APPROVAL <i>slw</i>	REQUEST FOR COUNCIL ACTION	MEETING DATE 05/21/19
REPORTS & RECOMMENDATIONS	A RESOLUTION CONDITIONALLY APPROVING A PRELIMINARY PLAT FOR OAK RIDGE OF FRANKLIN SUBDIVISION (AT 7475 SOUTH 49TH STREET) (FRED ARBANELLA, ARBANELLA/CARMODY HOMES, APPLICANT)	ITEM NUMBER <i>G, 3.</i>

Project Name:	Oak Ridge of Franklin CSM and Preliminary Plat
Project Location:	Approximately 7475 S. 49 th Street (Tax Key No: 759-9981-010)
Property Owner:	Walter Hablewitz
Applicant:	Fred Arbanella, Arbanella/Carmody Homes
Agent:	Timothy Lynch, Lynch & Associates Engineering Consultants, LLC
Current Zoning:	R-6 Suburban Single-Family Residence District
2025 Comprehensive Plan:	Residential
Use of Surrounding Properties:	Single-family residential to the north and east, vacant developable land to the south, and Payne & Dolan quarry to the west.
Applicant's Action Requested:	Recommendation of approval of the Certified Survey Map and Preliminary Plat for future single-family residential development

Date: November 27, 2018/Revised May 2, 2019

PRELIMINARY PLAT FOR
OAK RIDGE

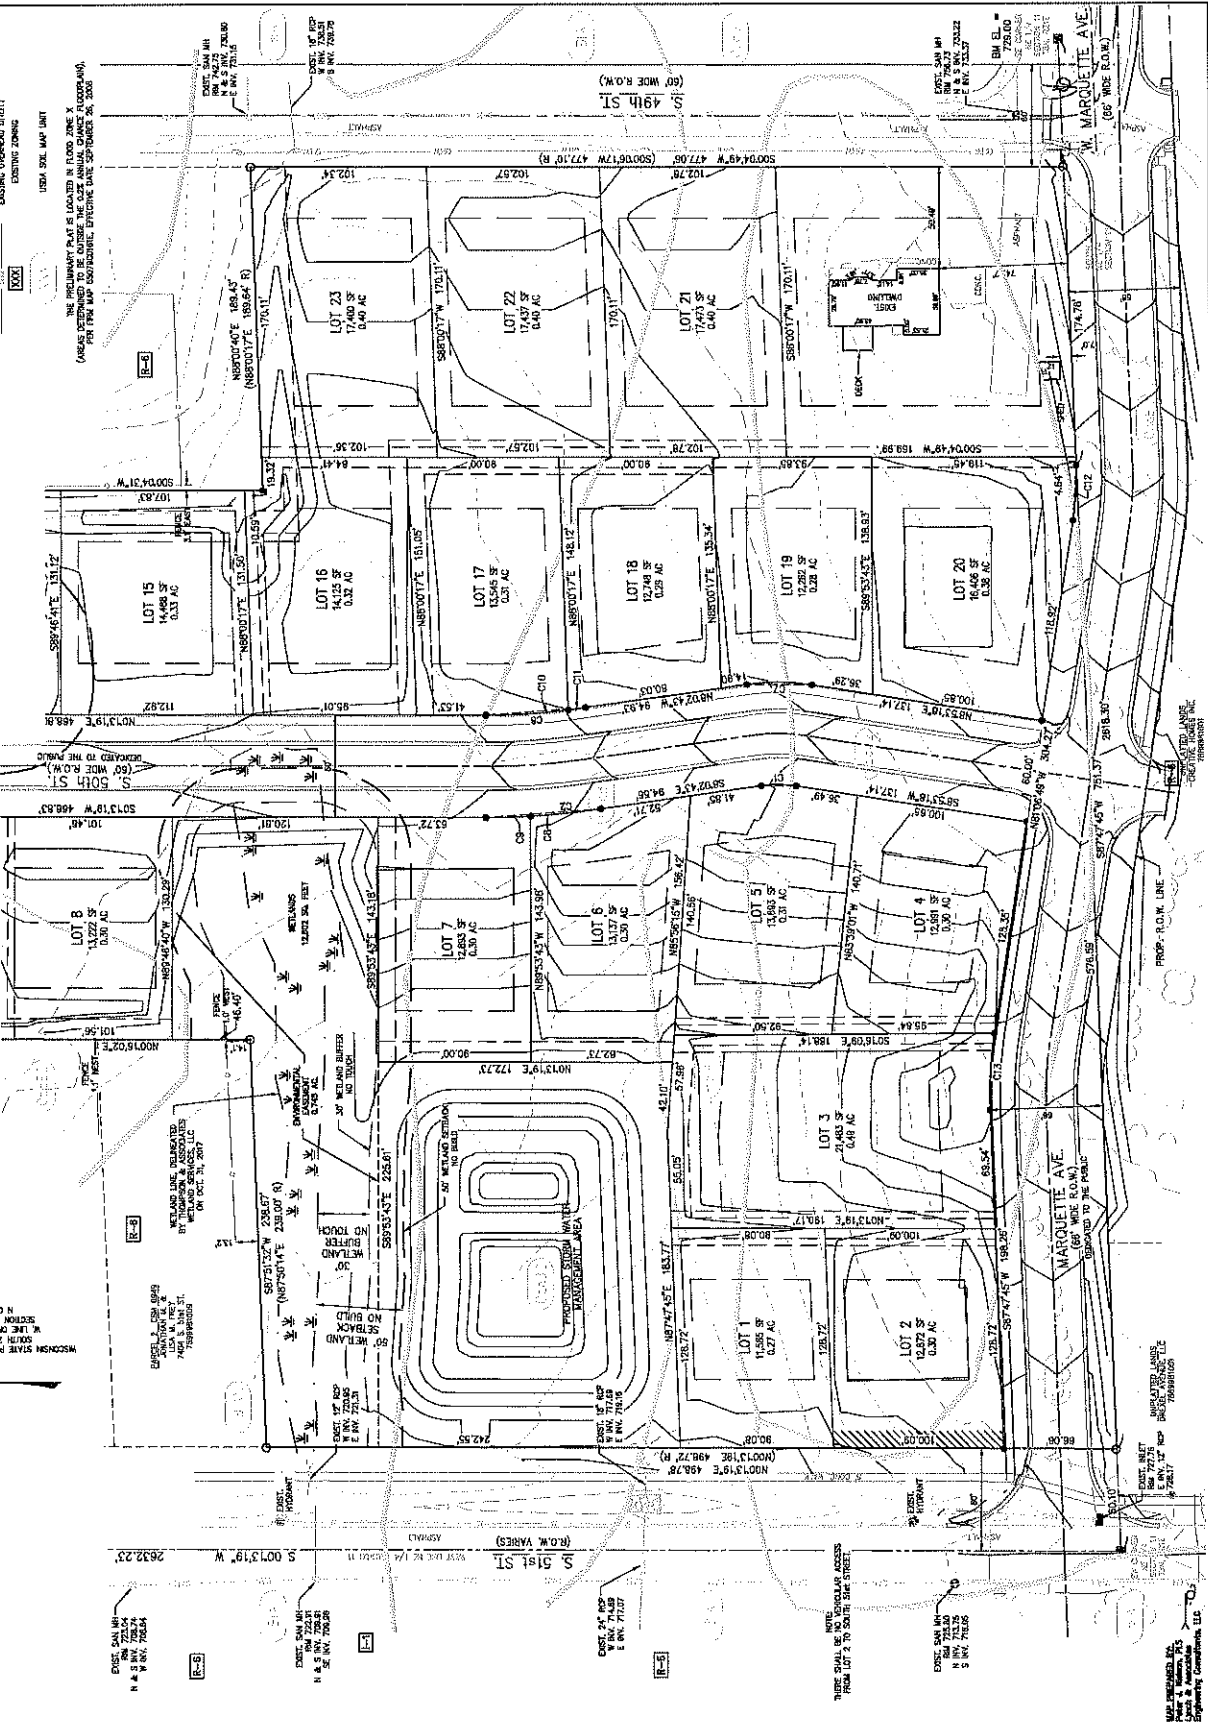
1. Please correct the pavement width of the proposed Marquette Avenue. Per Table 15-5.0103 of the UDO, the pavement width should be 36 feet (face of curb to face of curb). **ENGINEERING DEPARTMENT TO CONFIRM**
2. Please provide (and clearly identify) sidewalks on at least one side of all Minor Streets per Table 15-5.0103 of the UDO. **COMPLETED** This includes the portion of S. 49th Street adjacent to the subject property. **STILL REQUIRED**
3. Please note that street grades as required by Section 15-5.0103D. of the UDO may have been superseded by new standards in the City's Design Standards and Construction Specifications. You must contact the Engineering Department to obtain the latest most up-to-date requirements. **ENGINEERING DEPARTMENT TO CONFIRM**

6. Please provide utility easements along rear lot lines, and in mid-block locations where necessary, as required by Section 15-5.0105D. of the UDO. Please note that these utility easements are required to be shown on the Final Plat. STILL REQUIRED

7. Please revise the plat to provide the correct 90' of frontage for lot 11 (and adjust the adjacent lots as needed) as required by Section 15-5.0106D. of the UDO. COMPLETED

8. Please revise the plat to provide a minimum lot depth of 110' for lot 9 as required by Section 15-5.0106E. of the UDO. COMPLETED
9. Please add a vehicular nonaccess reservation restriction to the plat prohibiting direct vehicular access from lot 2 to S. 51st Street pursuant to Sections 15-5.0107A.1. and 6. of the UDO. COMPLETED

11. Please correct the Site Data to reflect 23 lots and 1 outlot, and to provide the density of the development, as required by Section 15-7.0501H. of the UDO. COMPLETED
 - a. In this regard, the existing home must be included in this plat as lot 20 (and the remaining lots renumbered), and the stormwater pond/remaining wetland identified as Outlot 1 on the plat.
12. Please correctly depict all existing setbacks, buffers, and building lines as required by Section 15-7.0501K. of the UDO. COMPLETED
 - a. Building lines/envelopes cannot extend into easements, please correct lot 22.

- a. For clarity purposes, staff recommends that this information be provided on a separate sheet as part of the Preliminary Plat.
- 14. Please depict all existing right-of-ways immediately adjacent to the Plat, as required by Section 15-7.0502F. of the UDO. STILL REQUIRED

- a. Include the correct right-of-way boundary on the east and south sides of the intersection of Marquette Avenue and 49th Street.
- 15. Please clearly identify and label utility locations on the face of the Plat as required by Section 15-7.0502I. of the UDO. STILL REQUIRED

- 18. Please graphically indicate and clearly delineate and dimension the location of proposed conservation easements on the face of the Preliminary Plat as required by Section 15-7.0502V. of the UDO. STILL REQUIRED, NOTE TO BE REVISED

28. Staff recommends that S. 50th Street be moved an additional 20' eastward. This would: provide additional depth (and area) to the lots along the west side of S. 50th Street; reduce the amount of impact upon the wetland and associated setback and buffer to the south of lot 7; and bring the lots west of S. 50th Street closer in size to the lots east of S. 50th Street. **COMPLETED**

29. Staff recommends that lots 2 and 3 be revised, in conjunction with moving S. 50th Street eastward, so that an additional lot can be provided between lots 2 and 3. **COMPLETED**

31. Staff recommends that the north lot line of lot 6 and the south lot line of lot 7 both be adjusted by about 10 feet to prevent any wetland buffer from extending into those lots. Staff also recommends that both lots be further revised to ensure that the wetland setback does not extend any further into the lots than the side yard setback. **COMPLETED**

- a. Staff suggests that both lots be revised to prevent any wetland setback from extending into the lots.
32. The Department of City Development recommends that the sidewalk on Marquette Avenue be located on the south side of the road, to match the location of the existing sidewalk by Pleasant View Middle School. **APPLICANT TO COORDINATE WITH THE ENGINEERING DEPARTMENT**

LYNCH & ASSOCIATES ENGINEERING CONSULTANTS, LLC
 440 MILWAUKEE AVENUE
 BURLINGTON, WI 53105
 CITY OF FRANKLIN, WI
 OAK RIDGE OF FRANKLIN
 MASTER GRADING PLAN

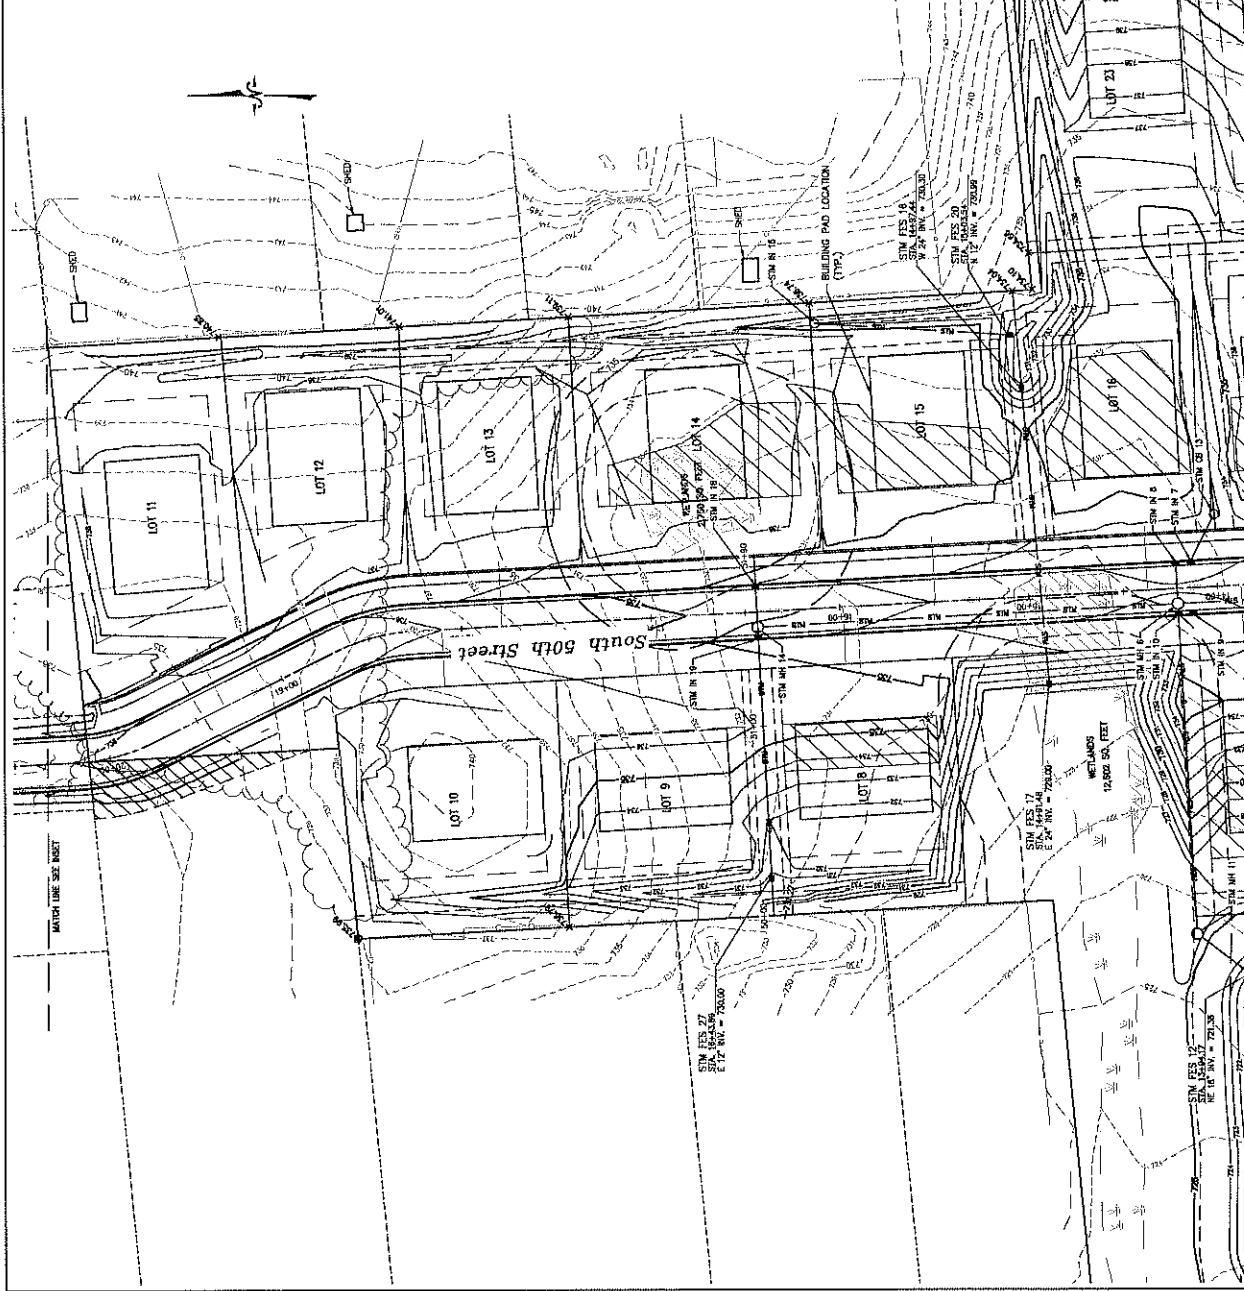
- b. The setback and buffer must be clearly shown and labeled on all portions of all wetlands.
 - c. On the Master Grading Plan, please revise lots 5 and 6 to show the correct building envelope, i.e. building envelopes cannot extend into the rear yard setbacks.
